# Drainage Technical Note

## PROJECT: 37 Albion Street, Southwick, Brighton

**Subject:** Response to LLFA Comments 15.07.2026

**Our Ref:** IP-2509-1061/TN01

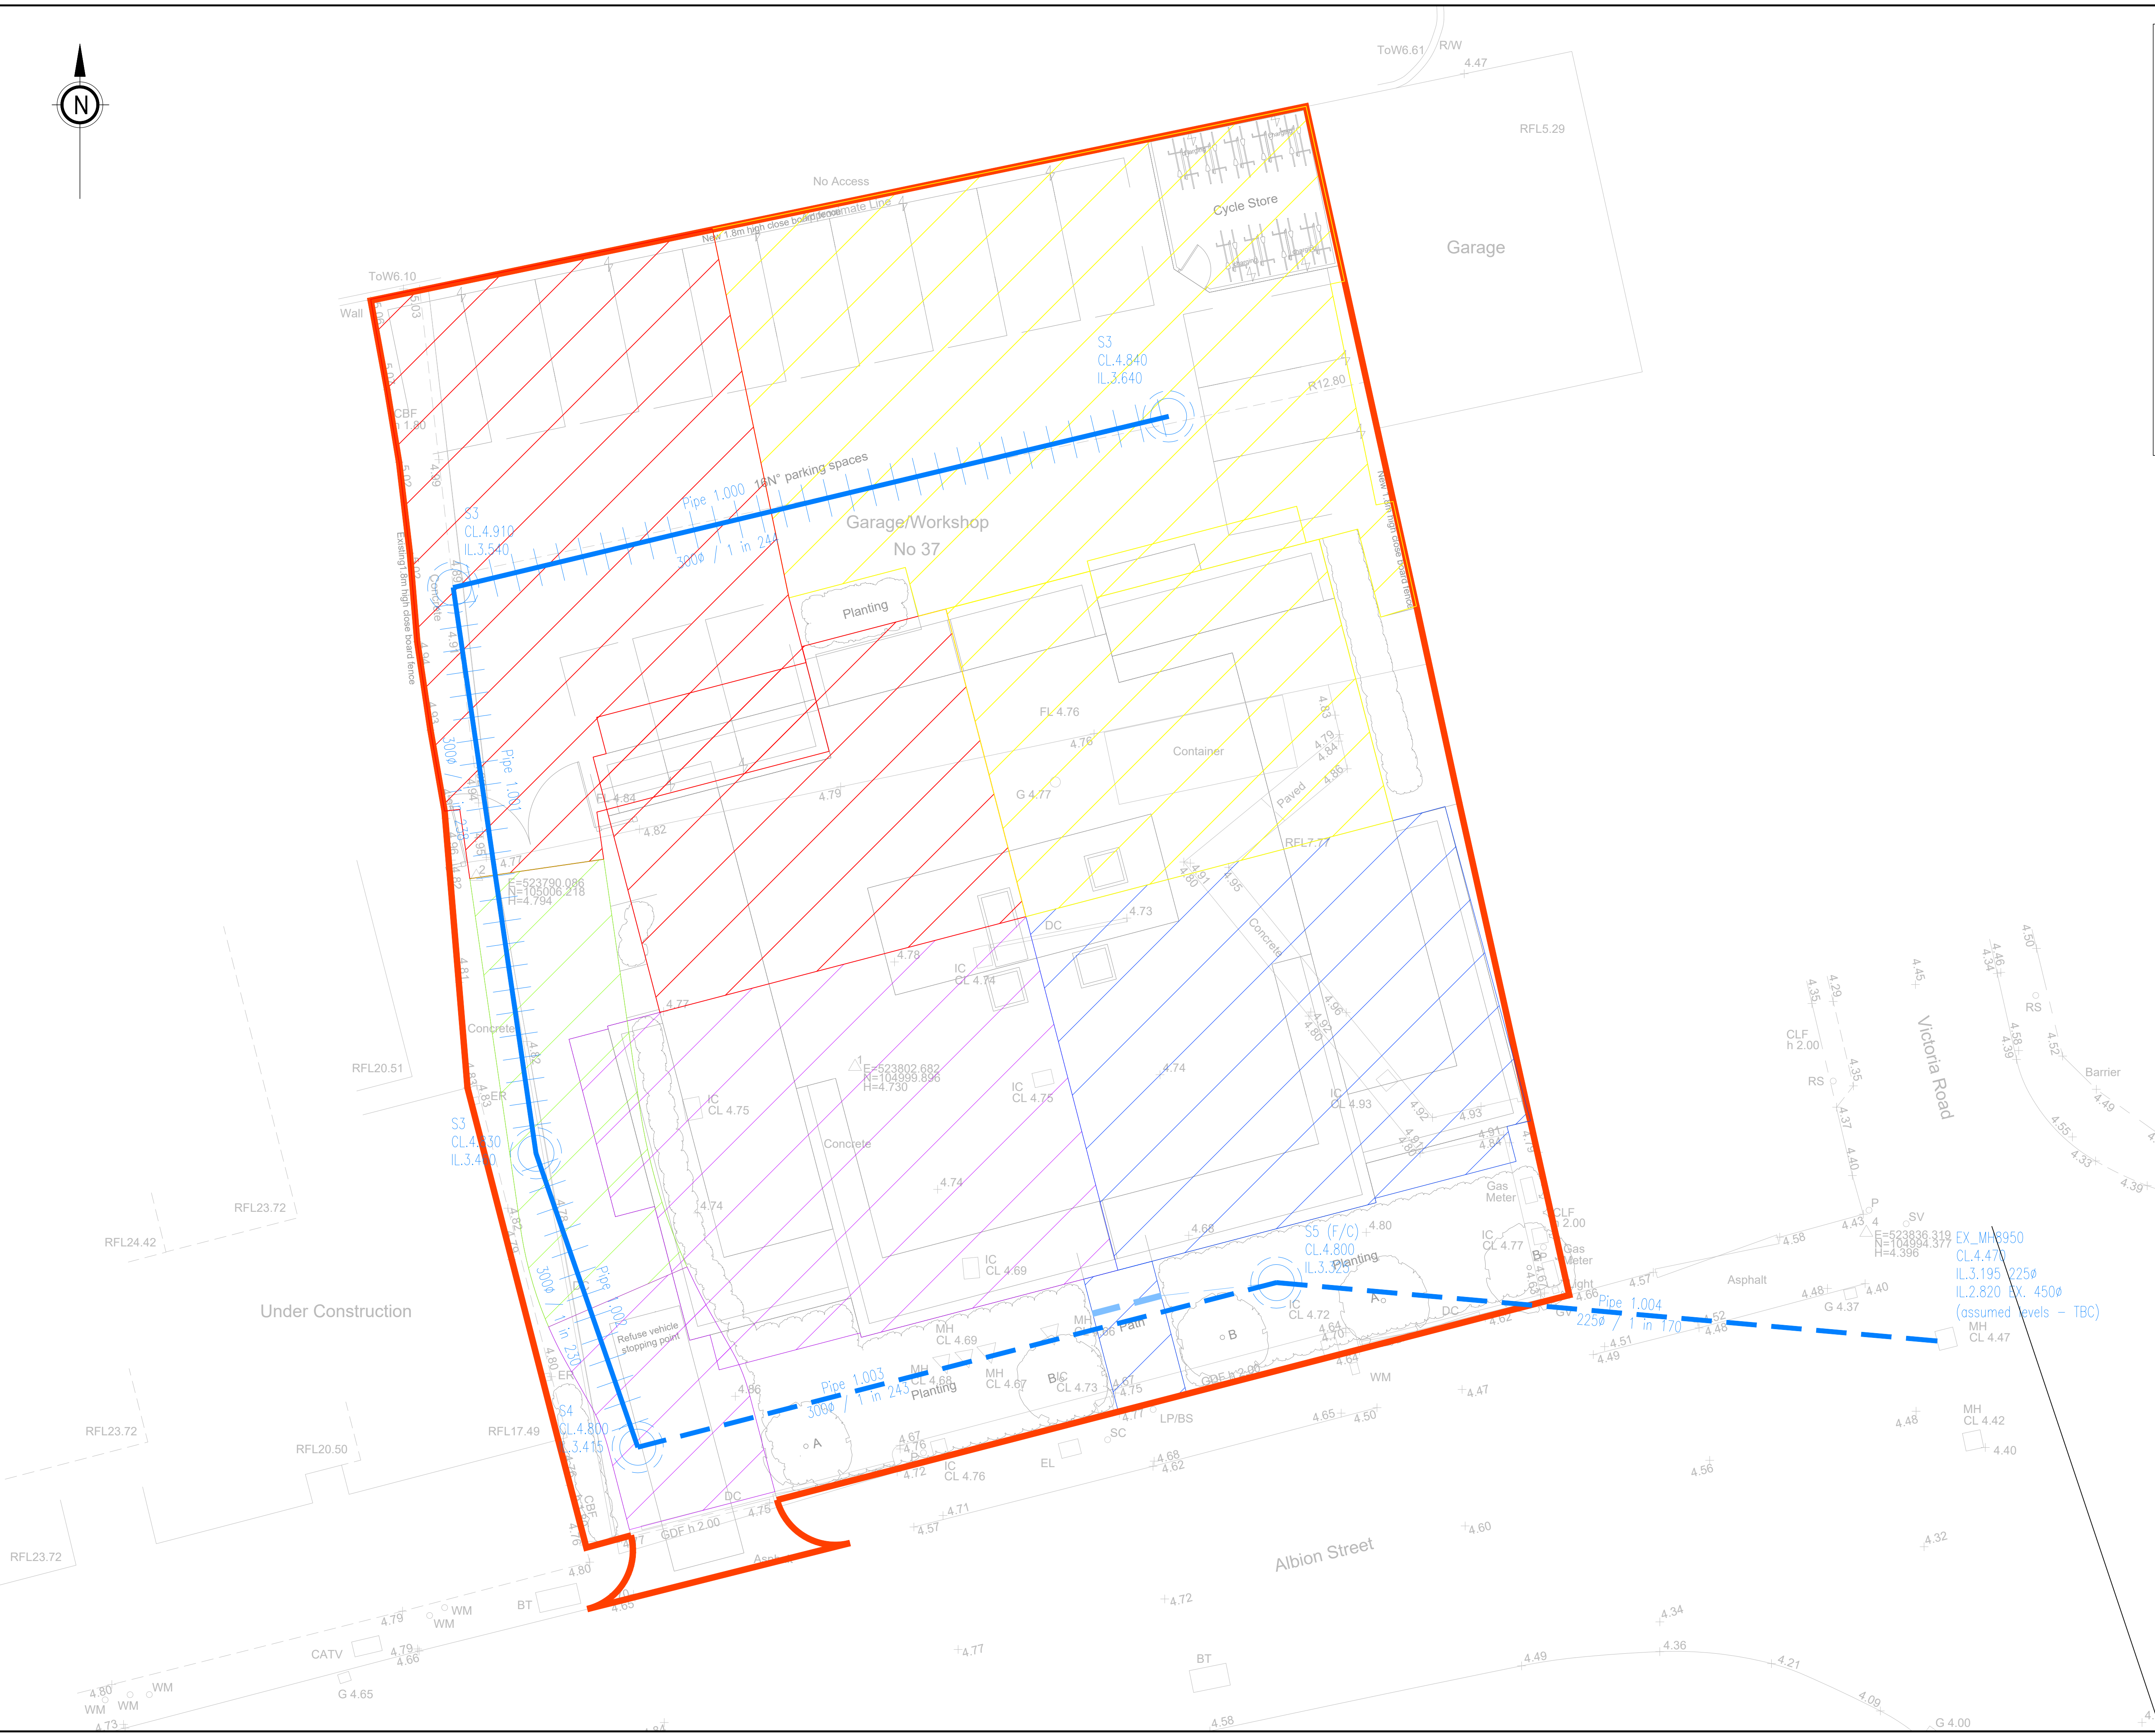
1. The Proposed Drainage Strategy (ref: 2509-1061 - ST001) has been revised to Rev. B to provide more details as set out in the LLFA comments. More detail has been added to inform of the proposals and provide further clarity. It also includes details of the approved connection points for both Foul and Surface Water as provided by Southern Water; detailed below in the next comment response.

TW APPROVED CONNECTION FOR SURFACE WATER (MH No. TQ23048950).  
IL FOR CONNECTION TO BE CONFIRMED. AGREEMENT WITH SOUTHERN WATER VIA PPE REF: DSA000050107; DATED 17.08.2026. CLASH DETECTION REQUIRED FOR PIPES AND OTHER UTILITIES.

TW APPROVED CONNECTION FOR FOUL WATER (MH No. TQ23048902).  
IL FOR CONNECTION TO BE CONFIRMED. AGREEMENT WITH SOUTHERN WATER VIA PPE REF: DSA000050107; DATED 17.08.2026. CLASH DETECTION REQUIRED FOR PIPES AND OTHER UTILITIES.

| B UPDATED IN LINE WITH LFA COMMENTS DATED 15.07.2026                                                                                                                                                                                                                                                                                                                                               |                  | SDM                               | SDM             | 26.08.26    |
